Docket Item # 14  
BAR CASE # 2008-0115

BAR Meeting  
July 30, 2008

**ISSUE:** Concept for an Addition and Alterations

**LOCATION:** 532 N. Washington Street

Figure 1. Existing conditions: front (east) elevation and rear (west) elevation.

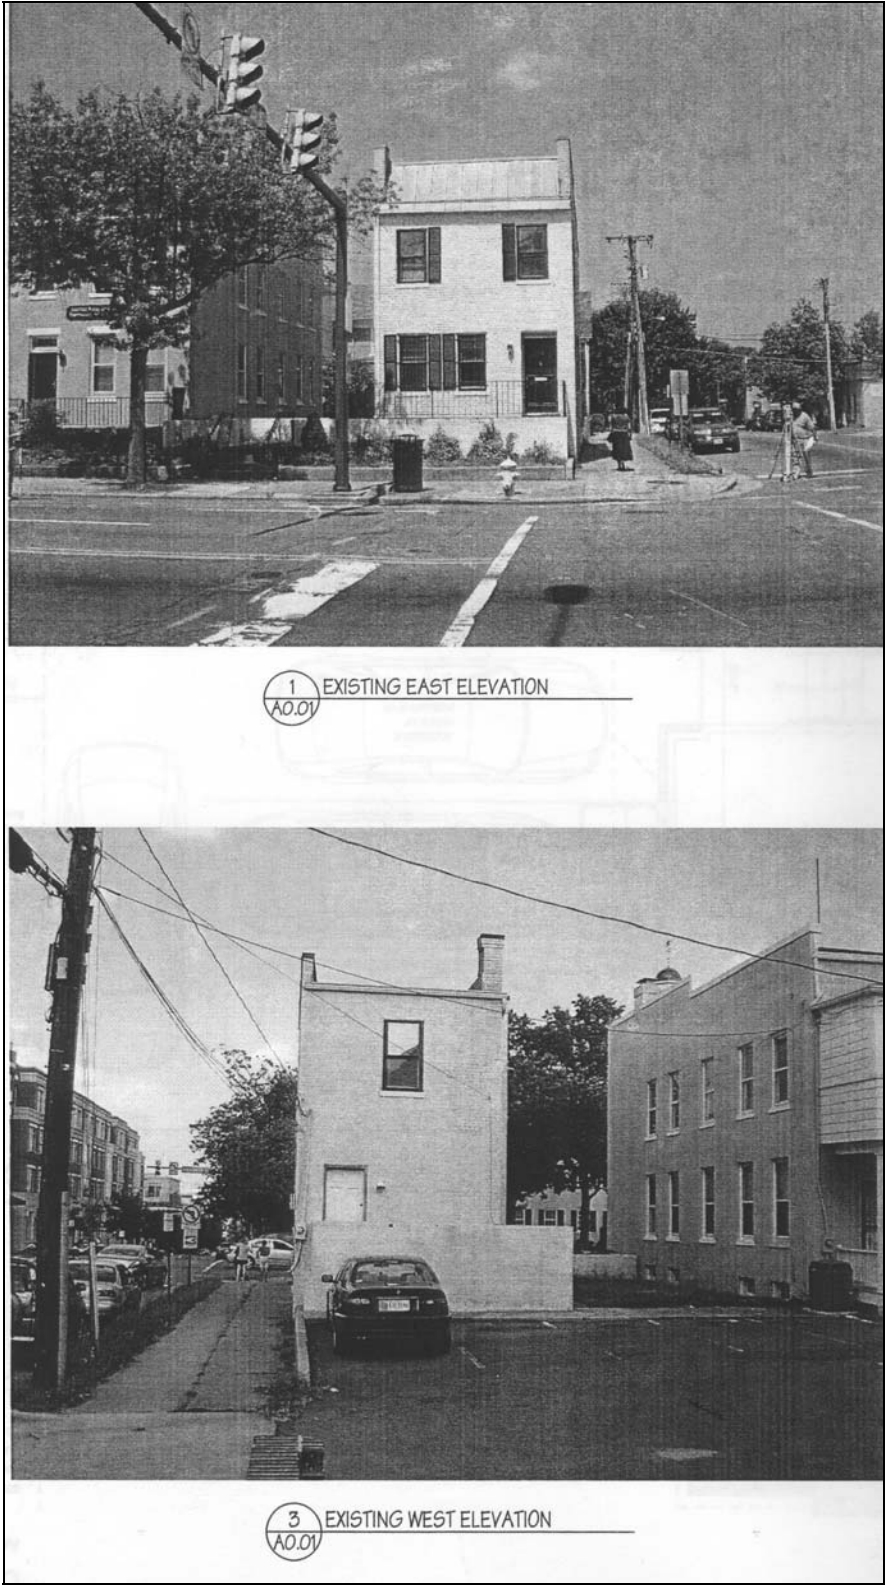
While it is often acceptable to remove portions of the historic fabric to accommodate new window and door openings, it is imperative to limit the extent of such alterations to retain the building’s integrity. Staff finds the removal of portions of the masonry wall on the front to install a new window in the center bay acceptable. However, Staff cannot support the moving of the front door as well. Staff finds that moving the front door removes a portion of the masonry wall unnecessarily as well as creates the need for a patched area where the door currently exists. Of great concern to staff is the removal and attempted replacement of a highly-textured, historic brick. The front façade features long, highly-textured brick with deeply recessed mortar joints. Staff finds this to be a character-defining feature on the front and believes that its demolition should be minimized.

Staff finds that the existing front porch, steps and railing are not original to the building. However, Staff recognizes that the building originally did have a one-story front porch, typical of the Washington-style rowhouse and considered by many to be a defining feature. Other buildings on the block, and in the surrounding area, retain the front porch. Staff finds that a one-story front porch is appropriate for this building and strongly encourages the applicant to explore the use of a front porch as the design evolves. Staff objects to the introduction of cast-iron stairs and a landing on the front elevation. Staff finds that such an addition represents the introduction of a new element for which there is no historic basis as well as alters the style and character of the building.

The applicant has proposed to remove all of the existing one-over-one, double-hung wood windows. A visual inspection reveals that these are likely the original windows. In 2002, the property owner submitted an application for a wholesale window replacement as well as other alterations (BAR Case # 2002-00224, September 4, 2002). At that time the Board approved a Certificate of Appropriateness for alterations with the condition that the original windows be retained and repaired. Staff recommends that the applicant retain and repair the existing, original wood windows. In addition, Staff recommends that the applicant reuse the original windows on the south and west elevations proposed for encapsulation for the new window openings proposed on the north and east elevations.

1. That demolition on the front elevation be reduced and specifically that the existing front door not be relocated in order to minimize demolition on the principle façade and protect the unique brickwork.

2. That the applicant not introduce new elements with no historical precedence, such as cast-iron stairs and a landing, on the front elevation. Further, the applicant should explore the restoration of the front porch, an appropriate historic feature and defining element of this style of building.

3. That the applicant retain and repair the original wood windows. In addition, the applicant should salvage and reuse original wood windows from the area proposed for encapsulation to be installed in the proposed new openings.

Figure 2. Existing conditions: side (north and south) elevations.

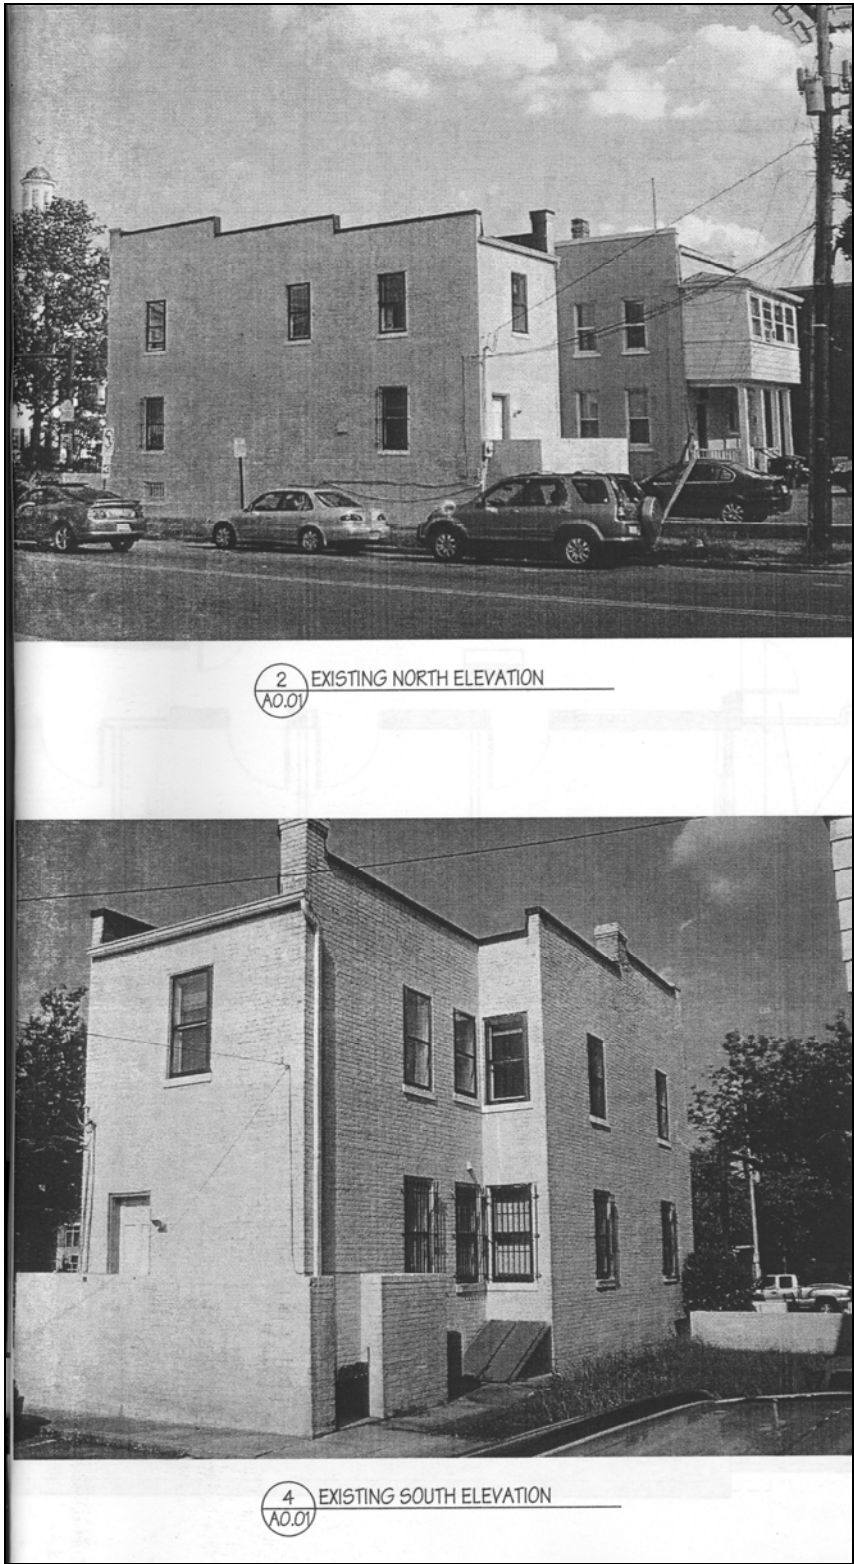
The applicant proposes to create two new window openings, one new louver opening, and one new door opening on this elevation. The brick on this elevation is common brick. Although visible from Washington Street, Staff finds the proposed alterations acceptable.

Figure 5. Proposed site plan.

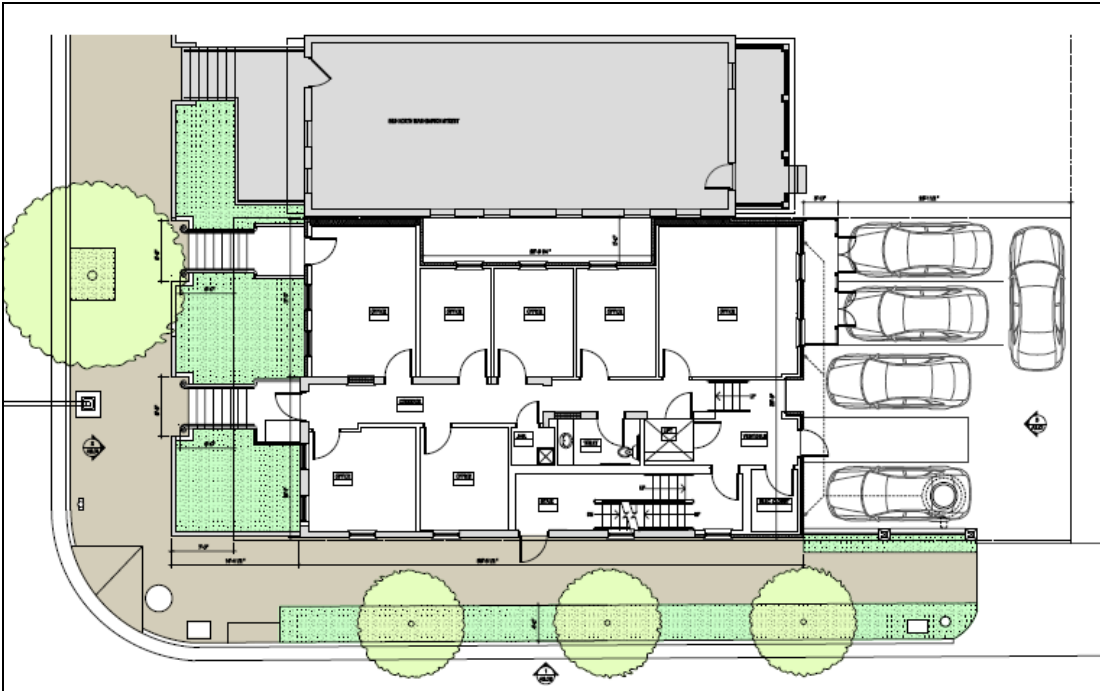
Staff has no objection to the proposed wood and masonry fence. Staff recommends that the proposed fence be no more than 6 feet in height and that the wood portion be stained or painted.

- F-1 The proposed project impacts on existing window openings for the adjacent property on the north interior lot line. The applicant shall meet with Code Enforcement Engineering section to resolve this conflict. Proposed construction shall comply with C-1 below.

4. That the wood portion of the proposed fence be stained or painted.
5. That the applicant work with Staff in determining appropriate specifications for details related to the addition.

- C-1 All exterior walls within 5 feet from an interior property line shall have a fire resistance rating of 1 hour, from both sides, with no openings permitted within the wall. As alternative, a 2 hour fire wall may be provided. (USBC 704.5).
